Report on Consultation process 2021 to 2023

The 3FM Project is the third and final project to be brought forward from the Dublin Port Masterplan 2012 (reviewed 2018). The 3FM Project concerns the development of additional port capacity in the south port area on the Poolbeg Peninsula, which contains nearly 20% of the overall Dublin Port estate.

3FMProject

3FM Project Preliminary General Arrangement

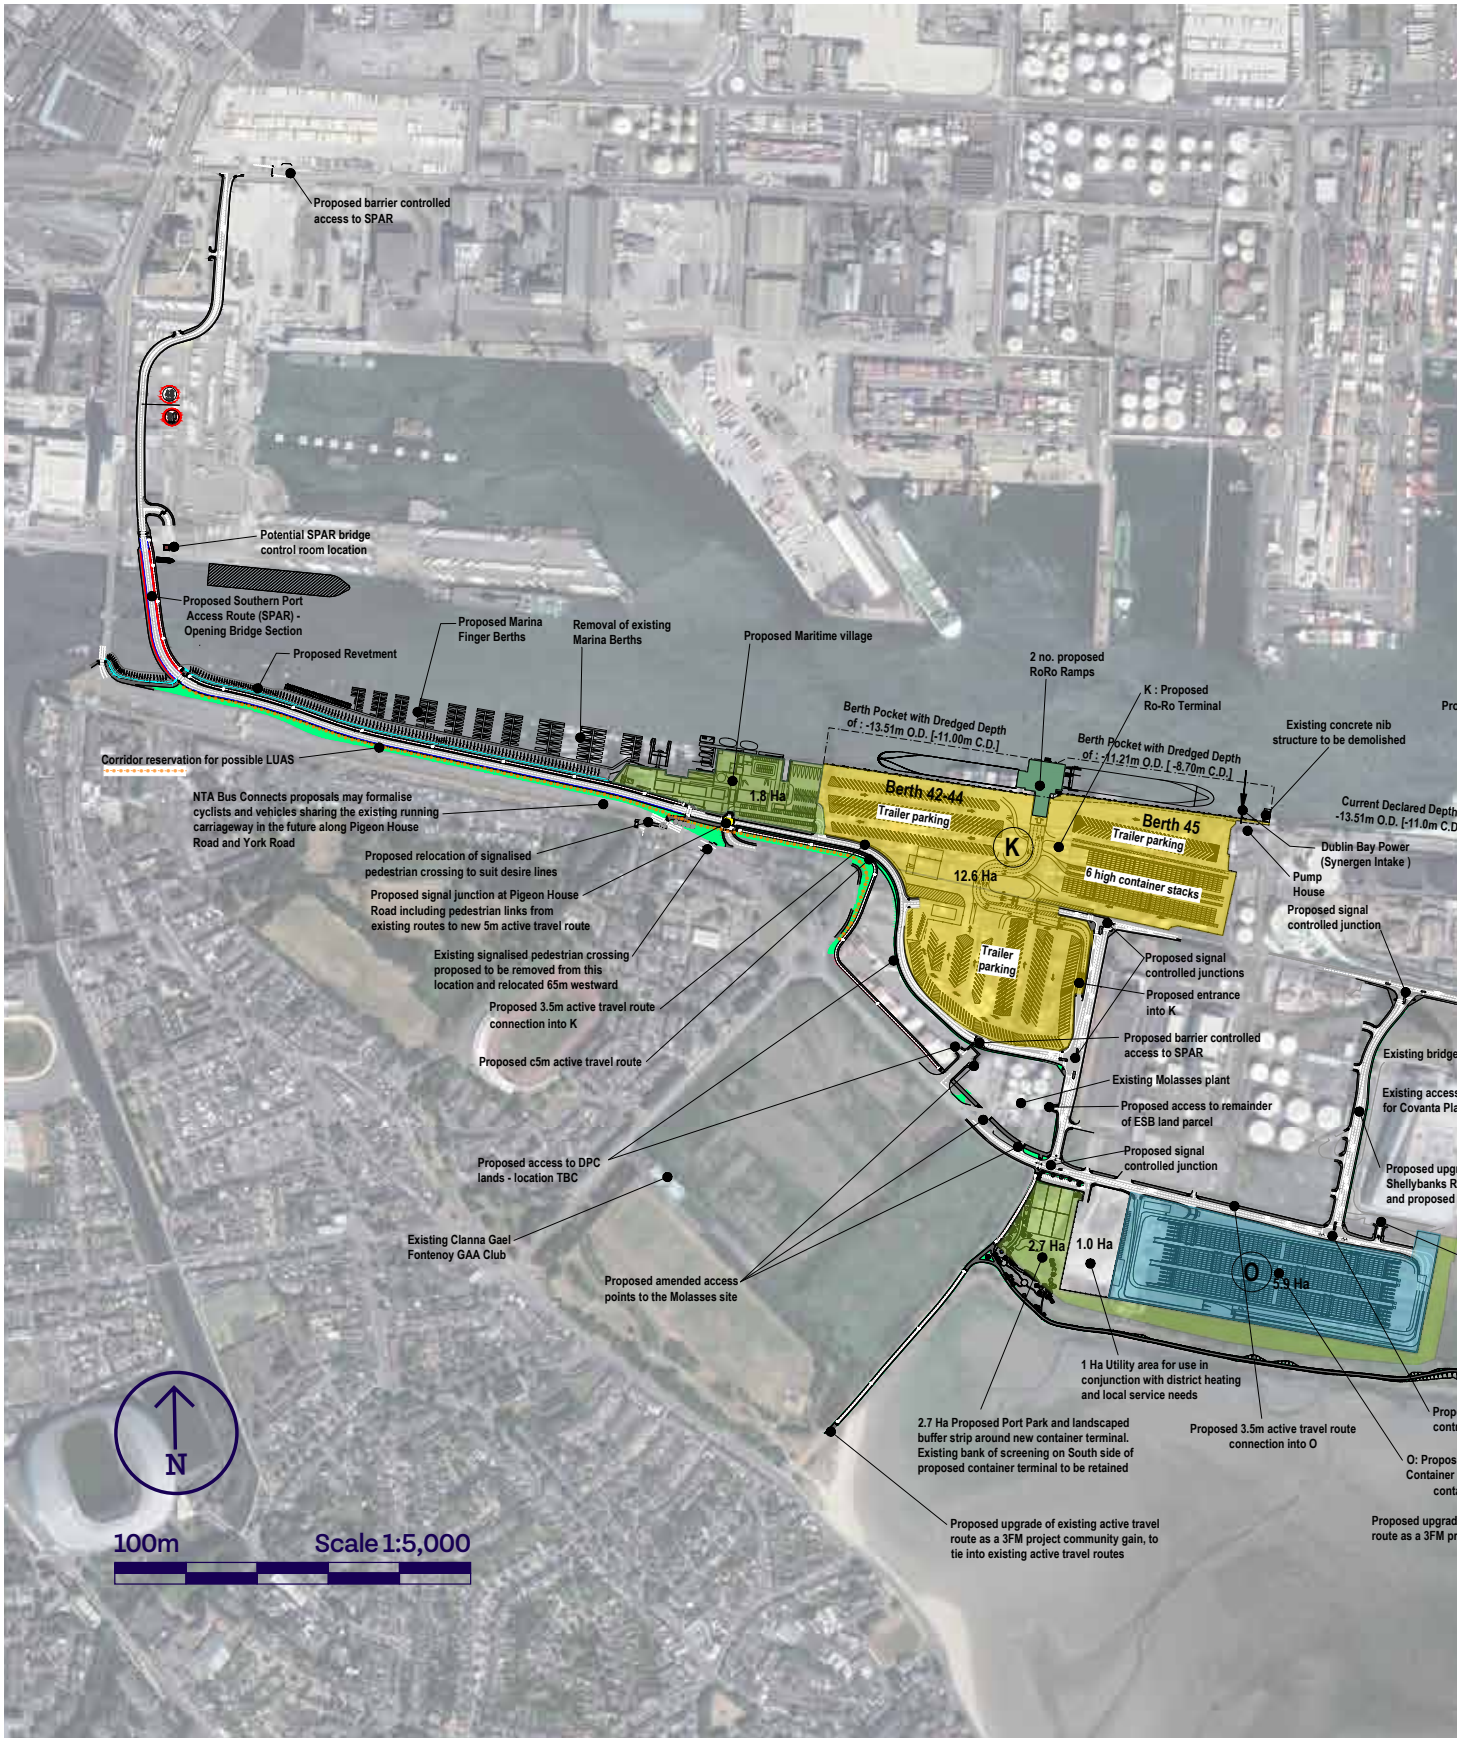
Observation	DPC comment
<p>The 3FM Project must comply with national policies on climate action, the circular economy, housing, and biodiversity.</p>	<p>DPC is deeply conscious of the responsibility and requirement to ensure that the 3FM Project is advanced in compliance with and with regard to all relevant national policies. This applies to both the development of the project and the subsequent operation of the facilities. Furthermore, DPC will need to demonstrate such compliance in any planning application to An Bord Pleanála before planning consent can be secured.</p> <p>Additionally, DPC notes the strong policy support for 3FM in the National Planning Framework, the National Development Plan, National Ports Policy, the Regional Spatial and Economic Strategy and the Dublin City Development Plan.</p>
<p>The 3FM Project places continued reliance on unsustainable modes of maritime trade and logistics.</p>	<p>Modes of maritime trade are set internationally and as a major port in an island nation, DPC must anticipate and respond to the realities of these trade modes. DPC believes that this can be done in a way that supports sustainability and maximises opportunities to reduce emissions.</p>

<p>The growth assumptions on which the 3FM Project is based are excessive and do not justify a project of this scale and nature.</p>	<p>The priority of all mercantile ports is to ensure that capacity remains ahead of demand. Taking a range of assessments and projections into consideration, DPC believes that there is a reasonable and well founded basis for the growth assumptions stated across the different cargo modes.</p> <p>In particular, DPC is keenly aware that in order to get planning permission from An Bord Pleanála it will be necessary to demonstrate that the 3FM Project is necessary, has a sound rationale, that the capacity cannot be delivered by any other alternative means and that it can be delivered in accordance with proper planning and sustainable development.</p>

Observation	DPC comment
<p>The 3FM Project needs to embrace rail freight.</p>	<p>Dublin Port is rail connected and the areas to be developed as part of 3FM will be rail enabled.</p> <p>Dublin Port has been an active supporter of rail freight for many decades. Ireland did have a significant rail freight network in the 1990s, with rail heads and hubs throughout the country, but this was dismantled by Irish Rail due to low market demand. Over the same period, DPC maintained its investment in rail, spending €1.2 million to build a dedicated rail spur to Ocean Pier which opened in 2011 and has been maintained ever since.</p> <p>Demand remains the key challenge for rail freight in Ireland with volumes continuing to decline. This is a function of a lack of geographic scale, low population density and small volumes. In addition, a world class route to market system linking Dublin Port to the M50 and the national motorway network via the Port Tunnel offers a highly competitive and effective alternative.</p> <p>DPC has advanced proposals to Irish Rail to increase rail access to Dublin Port, specifically by developing Irish Rail’s North Wall Freight Depot which is adjacent to the Port. This solution would provide access to the whole Port including the 3FM Project, without adversely impacting on critical port capacity.</p> <p>Ultimately, it will be a matter for Irish Rail to develop a detailed and costed business case for investment in rail freight in Ireland which addresses market demand, commercial viability, compliance with State Aid rules and environmental impact.</p>

<p>Rail is a means of decarbonising freight and should form a far greater part of the 3FM Project.</p>	<p>Dublin Port is already rail connected and the 3FM Project will also be rail enabled. Rail freight currently constitutes less than 1% of volume within Dublin Port with 50% of this volume coming from one customer (Boliden). Rail freight volumes have been declining steadily over the past decade.</p> <p>According to an Origin Destination Study completed for DPC by RPS, 73% of Port volume emanates from within 90kms of the Port. Initial analysis by RPS suggests that only a small portion of current Port volumes could even be suitable for rail freight. Developing the rail freight network would also require significant additional construction over a considerable period of time which will generate additional embedded carbon.</p> <p>Any such developments should also be viewed against improvements in the sustainability of road based transport due to new technologies and fuel mixes leading to significantly reduced emissions.</p> <p>Doubtless these are matters that will be addressed in the All Island Strategic Rail Review.</p> <p>The most effective short-term way of decarbonising freight is to ensure that low emissions HGVs are encouraged onto the national road network.</p>

Observation	DPC comment																
<p>Parts of the 3FM Project area should be used for recreation and amenity purposes, including a nature reserve, rather than commercial purposes.</p>	<p>The 3FM proposal is advanced in full conformity with the land use and zoning objectives of the Dublin City Development Plan, adopted in 2023 and the Poolbeg West SDZ, adopted in 2019.</p> <p>The 3FM Project includes specific proposals to create additional recreation and amenity space including the creation of new public realm, active travel, new parks and wildflower meadows. Some additional land will be ceded by DPC to the Irishtown Nature Park following the second consultation process.</p>																
<p>There are no capacity constraints in Dublin Port and the Port could operate more efficiently within its existing developed sites.</p>	<p>Dublin Port is already an exceptionally efficient port.</p> <p>The 3FM Project is the final opportunity to develop additional capacity at Dublin Port. There are already capacity constraints evident at Dublin Port, and the allocation of a significant part of the Port Estate to State Authorities in the context of Brexit has exacerbated this challenge, and has been highlighted by DPC.</p> <p>DPC remains committed to ensuring that capacity remains ahead of demand to prevent disruptions to mercantile trade through the risk of a national port capacity shortage with consequent constraints on economic development and the flexibility to deal with changes in mercantile trade.</p> <p>Dublin Port is already an exceptionally efficient port given the throughput from the land estate available to DPC, and from measures taken to intensify its use (development of Dublin Inland Port, Dwell Time Initiative & Pricing Policy for Customers, etc). This can be seen in a comparison with other European Ports, which suggests that DPC is securing very effective land use maximisation from the existing DPC estate;</p>

Observation	DPC comment
<p>The 3FM Project could have an adverse impact on flora, birds and other fauna.</p>	<p>Dublin Port exists within an area with significant levels of protected sites within the Natura 2000 network. DPC attaches considerable priority to the protection of natural habitats and is proud of the positive role that the Port has played in working closely with NGOs and State agencies to ensure that the natural environment is protected. DPC is acutely aware that in order to secure planning consent for the 3FM Project it will be necessary to demonstrate to An Bord Pleanála that the project does not adversely impact on the natural environment as protected by EU and national law.</p>
<p>Dublin Port should relocate to another unspecified location on the East Coast and the land be developed for housing.</p>	<p>The 3FM Project is entirely consistent with a range of national, regional and local planning policies on land that has been zoned by the local authority for port purposes as recently as 2023. Dublin Port has been developed over 300 years and is purpose built for Port use. It has the capacity to expand upon its existing lands. Located at the heart of the market and the economy that it services, it is the entry point to a world class route-to-market system which includes Dublin Tunnel, the M50 and the national motorway network – a point which cannot be overlooked when discussing a Port’s competitive and core strategic position.</p> <p>It is extremely doubtful that there is any other site on the East Coast to which Dublin Port’s activities and the wider supporting transport infrastructure could be relocated having regard to the enormous cost and permitting challenges that any such development would face. It is also likely that any such mega-project would take at least 20 years during which time the needs of the national economy would still need to be served. Additionally, diverting trade currently arriving in Dublin Port to other ports does not represent a sustainable option given the requirement to bring goods back to the Dublin area, which is where the core market served by Dublin Port is based.</p>

Observation	DPC comment
<p>Area O should not be used for container storage and should be used for parkland, amenity and nature.</p>	<p>Area O is required to service imports arriving in Lo-Lo mode to Dublin Port and was identified as such in the Dublin Port Masterplan (reviewed 2018). It is not intended that Area O will be a static storage area, but instead a short stay area for containers once they arrive in Ireland. The use of Area O for this purpose is entirely consistent with the Dublin Port Masterplan, the land use and zoning objectives in the Dublin City Development Plan and the Poolbeg West SDZ.</p> <p>Area O will be designed and operated in a way that is consistent with the land use and takes account of the need to protect residential amenity. This will be achieved through low stack heights, the use of electric gantries and container handling vehicles with significant levels of investment in screening, planting and noise reduction. The 3FM Project also includes the creation of significant new parkland, amenity and recreation space, including the allocation of some additional land to the Irishtown Nature Park and the creation of a new wildflower meadow adjacent to Port Park.</p>

<p>The 3FM Project will need to take account of all other developments in Dublin Bay.</p>	<p>As a core part of the planning application to An Bord Pleanála, DPC will be obliged to provide an assessment of the 3FM Project in combination with all other relevant projects.</p>
<p>The 3FM Project will bring additional noise, traffic and pollution as well as an eyesore.</p>	<p>DPC will need to establish for An Bord Pleanála, that the 3FM Project is in the interests of proper planning and sustainable development in order to secure planning permission. A key part of establishing this will be to demonstrate that the project will not have adverse impacts from noise, traffic, pollution or visual amenity perspectives and detailed assessments and reports will be required to prove this to ABP. The research to date indicates that the project will, in fact, make significant improvements in noise, traffic, and reduced pollution.</p>

<p>The impact of 3FM on the adjoining road network (including the Dublin Tunnel) needs to be carefully assessed.</p>	<p>DPC is engaging with DCC, TII and NTA to discuss the traffic and transport issues. Detailed traffic assessments are being prepared and will be furnished as part of the planning application. The SPAR, by removing freight and commercial traffic from adjoining existing roads is likely to be a significant improvement on existing traffic. Additionally, the development of Active Travel Routes will aid permeability for pedestrians and cyclists.</p>

Observation	DPC comment
<p>The SPAR should facilitate the expansion of the LUAS into the Poolbeg Peninsula.</p>	<p>A Luas extension to Poolbeg forms part of the Transport Strategy for the Greater Dublin Area, 2022-42, and will be subject to future route selection, planning, design, and appraisal work by the National Transport Authority (NTA). The route has yet to be determined. To preserve the option of choosing a route adjacent to the SPAR in the future, the SPAR Bridge has been designed such that it could be subsequently modified to accommodate a dual track Luas, if this was the NTA's final chosen Luas alignment.</p>
<p>Will rising sea levels be factored into the 3FM Project?</p>	<p>Yes – as part of the design and assessment of the 3FM Project, detailed assessments will be made of tidal and flood levels. Information on these assessments will be made available in the planning application to An Bord Pleanála.</p>

<p>The 3FM Project does not take account of the impact on leaseholders operating in the port estate and the impact that the development will have on their businesses.</p>	<p>The 3FM Project takes full account of the impact of the proposed development on all stakeholders, including leaseholders. DPC engages with all leaseholders and will continue to do so in the context of the development of the 3FM Project.</p>
<p>Will 3FM negatively impact on the quality of the sea water in the area, particularly given the high numbers of people sea swimming at present?</p>	<p>DPC has engaged extensively with the Marine Institute in the preparation of the 3FM Project to ensure that water quality is not adversely impacted. DPC is conducting detailed water quality assessments and will be required to demonstrate that water quality is not adversely impacted by the 3FM Project with consequent negative impacts for fisheries, the natural environment, and adjacent recreational users, including swimmers, divers and anglers.</p>

<p>Wind turbines should be included as part of the project within the Port Estate</p>	<p>DPC is taking a major step to facilitate renewable energy, by making land available to the Codling Wind Park Project for the construction of an onshore substation to facilitate the transmission and distribution of Offshore Renewable Energy from the Codling Bank to the National Transmission System.</p>
<p>The 3FM Project will add considerably to congestion in Dublin, including an up to 75% increase in M50 traffic and increased traffic stagnation in the City Centre.</p>	<p>3FM will not lead to a 75% increase in traffic on the M50. In fact at present HGVs traveling to or from Dublin Port currently account for 1.7% of all traffic on the M50 from the M11 to the M1 (RPS Origin/Destination Study 2023). Equally the project will not increase congestion in the City Centre, given that HGVs are excluded from the city and typically exit from the Port through the Dublin Tunnel, rather than secondary routes. As part of the planning application, DPC will be required to identify the traffic impact from the 3FM Project and to demonstrate to An Bord Pleanála that the traffic arising will not adversely impact on traffic flows. In fact, the advent of the SPAR should assist with traffic flows, by taking commercial vehicles off existing adjoining roads.</p>

Observation	DPC comment
<p>Dublin Port should follow the European example of moving out of the City and to a new greenfield site.</p>	<p>European Ports are not moving away from urban areas. The norm, rather than the exception, for European port cities is to remain close to their core markets and to remain a key part of the urban settlements that the Port contributed to establishing. Ports are focusing on Port/City integration with their adjoining cities and communities – Dublin Port is actively delivering on its Port-City Integration Programme and the 3FM Project builds on this initiative.</p>
<p>Rosslare should be an effective substitute for Dublin Port.</p>	<p>Rosslare Europort will continue to play an important role in complementing Dublin Port however it has nowhere near the potential capacity to replace Dublin Port.</p> <p>At present, Rosslare Europort handles 10% of National Freight volume, 13% of European trade and is running close to capacity.</p> <p>By contrast, Dublin Port handles 80% of national freight, 68% of European cargoes, and sits on an existing brown field site with potential to build additional Ro-Ro and Lo-Lo capacity.</p> <p>Rosslare Europort handles Ro-Ro freight only and as European demand increases, Lo-Lo facilities will become increasingly important. Any future marine infrastructure development in Rosslare will be expensive (particularly if breakwaters are required - as is most likely if Lo-Lo operations are to be considered), and pose significant permitting challenges given its location amidst a cluster of Natura2000 sites.</p> <p>In terms of location, Rosslare Europort is located 155km from Dublin. Assuming berth and land capacity can be secured, a major investment in the existing train line and freight handling facilities would also be required in order to move freight by rail.</p> <p>Given challenges with the Dublin/Rosslare rail line, it is possible that freight from Rosslare to Dublin may need to come via Waterford through the currently closed Rosslare to Waterford rail line.</p> <p>Additional capacity would be welcome in Rosslare Europort however its potential will be limited relative to the scale required.</p>

<p>Why bother with the 3FM Project if Dublin Port is going to reach capacity by 2040?</p>	<p>DPC has indicated that Dublin Port will reach capacity in or around 2040. Following 2040 Dublin Port will continue in its role as Ireland’s largest port – a factor of its location, connectivity with national networks and navigability. Post 2040 it is likely that some <i>additional</i> port capacity will be required on the East Coast to augment Dublin Port’s throughput. Given the long tail in any new infrastructure development, this additional port capacity could take up to 20 years to bring to fruition. It will not be a replacement for Dublin Port, but will likely work in tandem with Dublin Port to serve the national economy.</p>

Observation	DPC comment
<p>Dublin Port has no regard for Climate Action or reducing carbon emissions.</p>	<p>DPC's plans are fully aligned with Climate Action goals. Dublin Port is keenly aware of the need to meet the targets set out in the Climate Action Plan and will have to demonstrate this to An Bord Pleanála. Separately and through targeted initiatives DPC is working to reduce its carbon emissions - through low carbon fuel options for vehicles, electricity services for shore to ship power, facilitating the connection of Offshore Renewable Energy to the national grid as well as facilitating efficient rail connectivity.</p>
<p>Dublin Port lands are ideal for housing.</p>	<p>Dublin Port is specifically zoned for port uses and not for residential use. Most of the Dublin Port lands are in areas with a high industrial or utility function and both within and adjacent to the Port Estate where facilities include, Electricity Generation Stations, Waste Water Treatment Plants, a Cement Factory, Strategic Oil Storage Tanks, Bitumen and Molasses storage facilities and a Waste to Energy plant. The area is also traversed with the infrastructure required to service these facilities, including HV power cables and pipelines carrying a range of materials. These areas are not suitable for residential development and, in many instances, are expressly excluded from such use as a consequence of Health and Safety requirements. It is also an important point to bear in mind that Dublin Port does play a vital role in the provision of housing, given that so many of the component elements required for Ireland's construction sector come through the Port.</p>
